Auxiliary Battery Charging, Improvement

V-321-002

(December 2024)

Volvo truck models with USA17 and USA21 emissions levels, Aux. Power/Climate Systems and a LeeceNeville alternator.

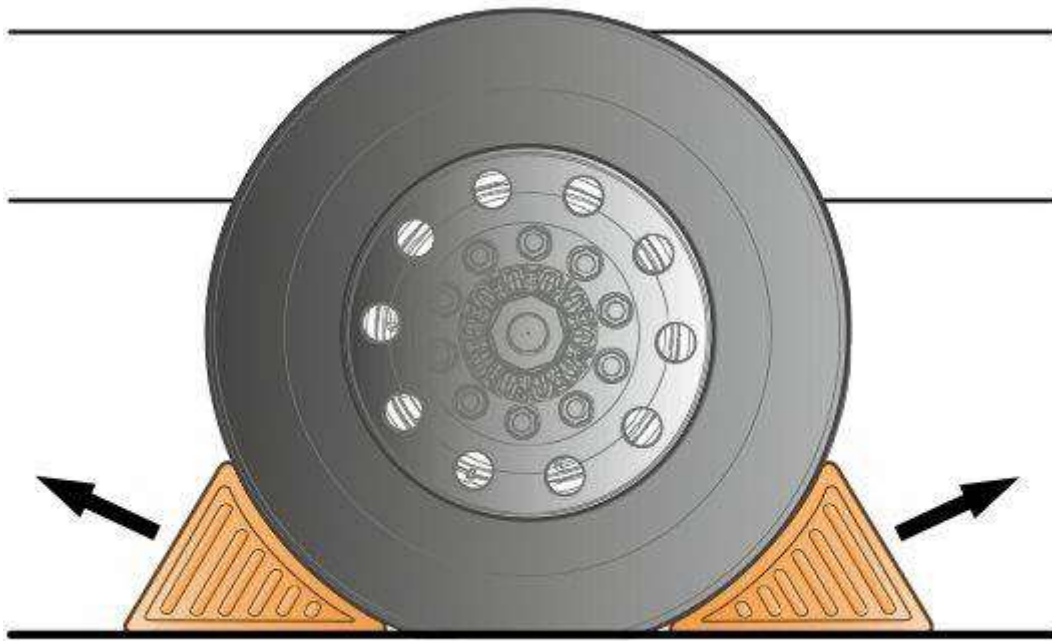
5. Replace the following parts.
 - Alternator with P/N-24112498
 - Alternator Pulley with P/N-23963356
 - Alternator Belt with P/N-24428844
6. Remove the wheel chocks.
